Re: El Parador Multi Family Development/ 201 Yale Blvd. SE
Request for Certificate of Occupancy
Transportation Development Final Inspection
Engineer's Stamp dated 01-28-22 (K15D107)
Certification dated 03-12-25

Re: **Permanent Certificate of Occupancy for
El Parador, 201 Yale Blvd SE
Albuquerque, NM 87106**

PROJECT
El Parador Multi-Family Development
201 Yale Blvd. SE
Albuquerque, NM 87106
TITLE
Traffic Circulation Layout - AS-BUILT

SHEET
TCL

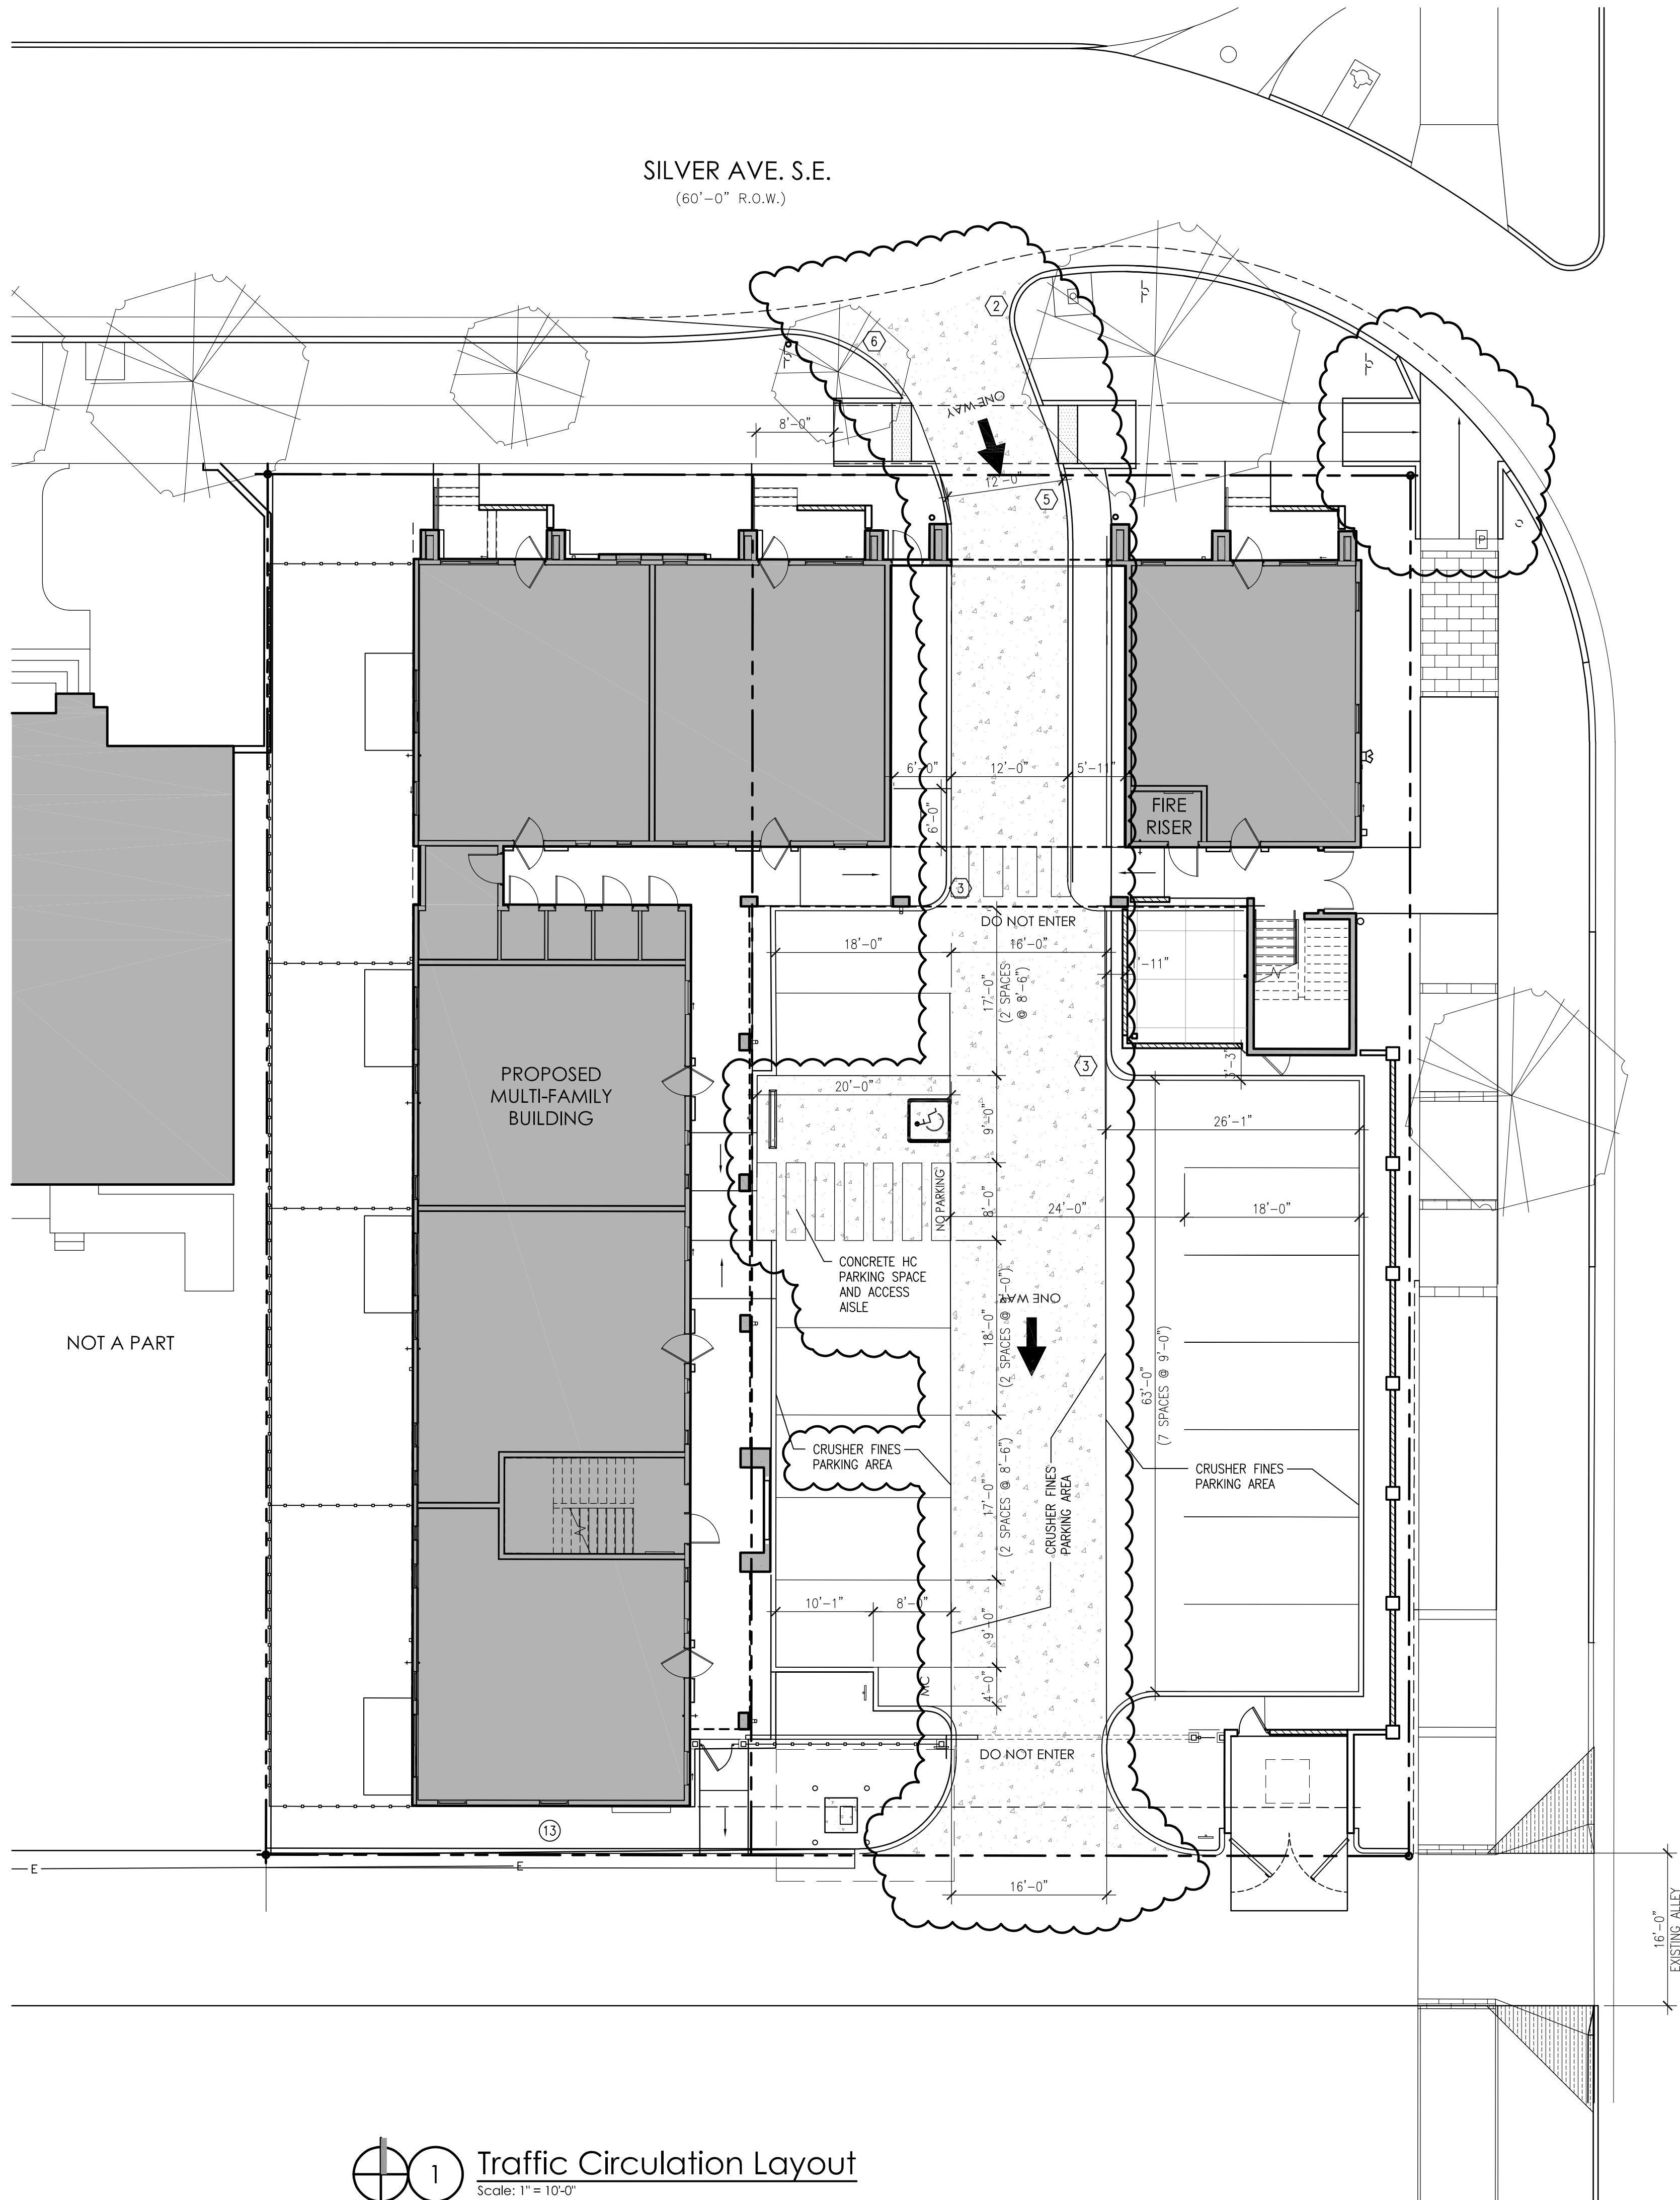
The construction of the sitework matches the approved permit drawings with a few minor exceptions, which include:

- The entry driveway off of Silver Avenue was reduced from 16' wide to 12' wide due to existing conditions – to maintain the existing trees along Silver. The driveway still remains one-way.
- The Owner made the decision to soften the parking areas by utilizing crusher fines. The drive aisle within the site is 16' wide paved with concrete.
- The one-way exit to the alley has been reduced to 16' to move the drive way further west from Yale.
- Additionally, the new curb ramp at the corner of Silver and Yale was reworked with the approval of Mr. Biazar, who visited the site with the contractor. The existing conditions of the existing sidewalk did not allow for the proposed ramp to be installed.
